Wisconsin Department of Transportation

August 2024

Standard Detail Drawings Updates

Summary of new or updated SDD's:

GENERAL NOTES AND HARDWARE FOR OVER HEIGHT TYPE 9, 10, 9/10 SPECIAL. 12 AND 13 POLES WITH MONOTUBE ARMS

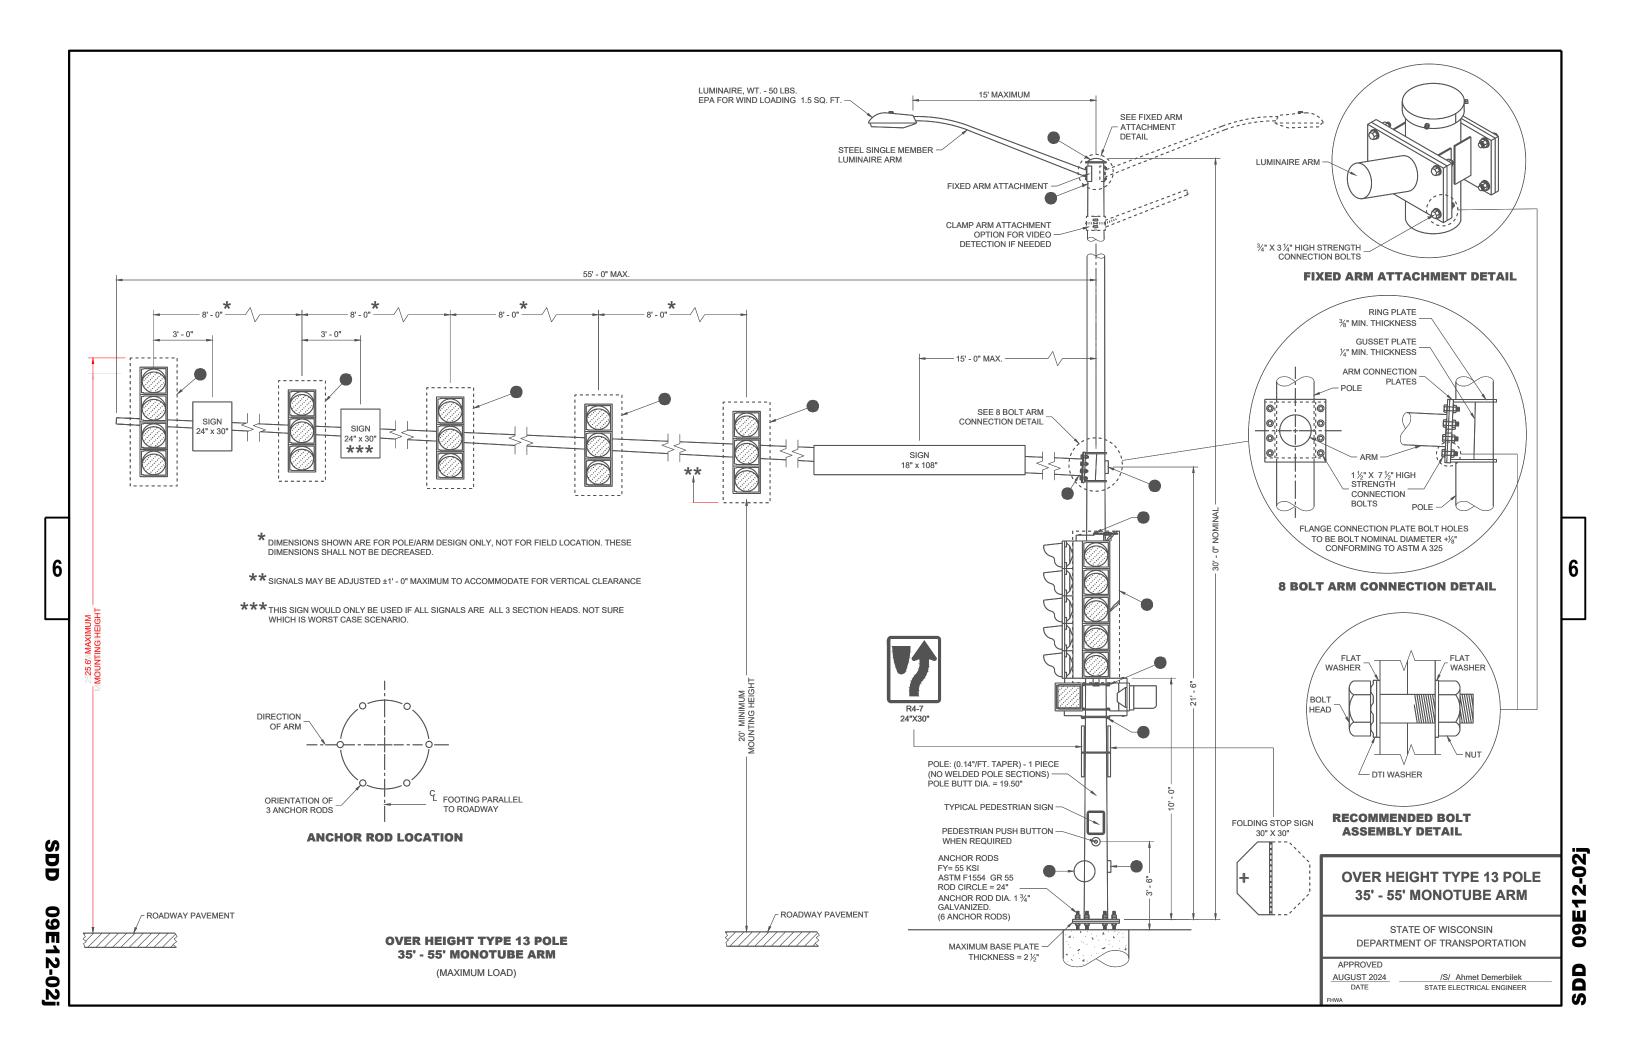
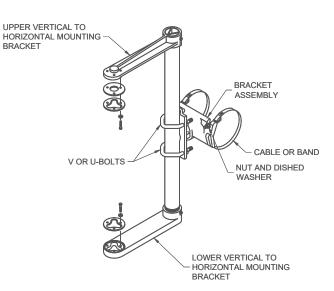
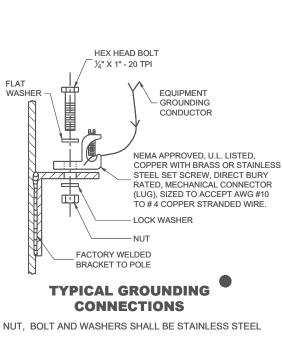
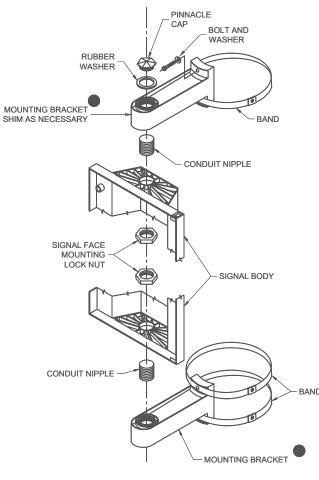
<u>09E12</u>	v.2	New SDD Over Height (OH) Type 9 & 10 Special Monotube Pole on the SDD list.
15C18	v.9	Add a painted median SDD 15C18 sheet c
<u>15C31</u>	v.7	new MUTCD

OVER HEIGHT POLE TYPES 9 SPECIAL AND 10 SPECIAL ARE FOR ARM LENGTHS 35 FOOT, 40 FOOT, AND 45 FOOT

CATEGORY II FATIGUE LOADS OF TRUCK GUSTS (AT 45 MPH VEHICLE VELOCITY) AND NATURAL WIND GUSTS FOR DESIGN OF OVER HEIGHT TYPE 9 SPECIAL AND TYPE 10 SPECIAL STRUCTURES. IN LIEU OF DESIGNING FOR GALLOPING, A VIBRATION DAMPER MITIGATION DEVICE IS REQUIRED TO BE SUPPLIED AND INSTALLED AT THE END OF THE MAST ARM.

TYPICAL PLACEMENT OF PAVEMENT MARKING ON MEDIAN ISLANDS

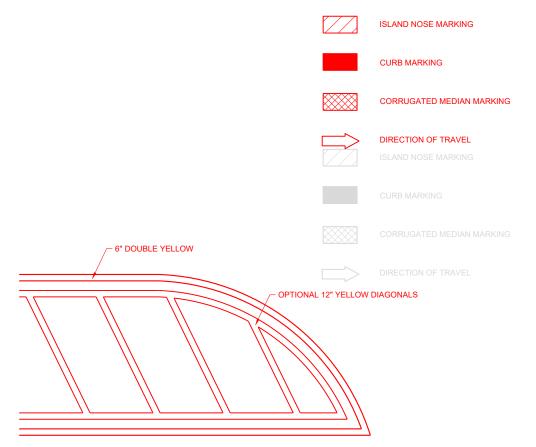
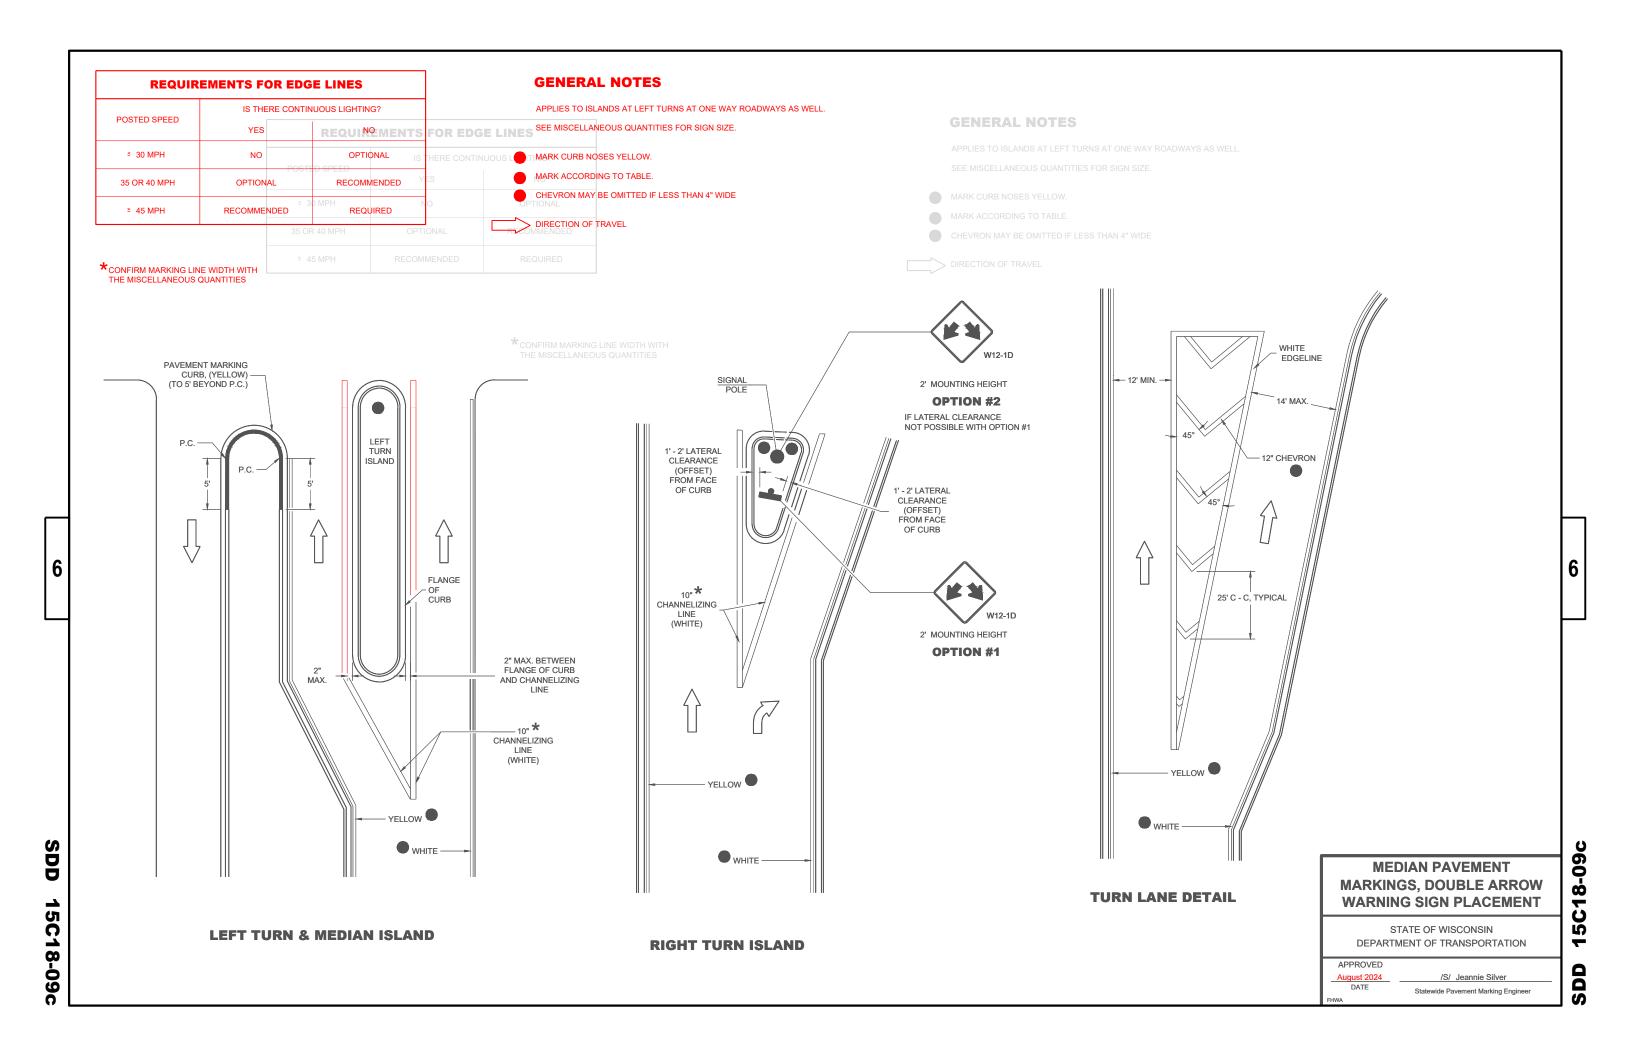
WHEN CONCRETE CORRUGATED MEDIAN IS CONSTRUCTED TO SEPARATE TRAFFIC OPERATING IN THE OPPOSING DIRECTION, YELLOW PAVEMENT MARKING SHALL BE APPLIED TO THE FLAT PORTION OF THE CONCRETE CORRUGATED MEDIAN. THE ITEM OF PAVEMENT MARKING, CONCRETE CORRUGATED MEDIAN, WILL BE MEASURED IN PLACE AND ACCEPTED IN ACCORDANCE WITH THE CONTRACT AND PAID FOR AT THE CONTRACT UNIT PRICE PER SQUARE FOOT.

APPLY PAVEMENT MARKING TO THE FLAT PORTION OF CORRUGATED MEDIAN.
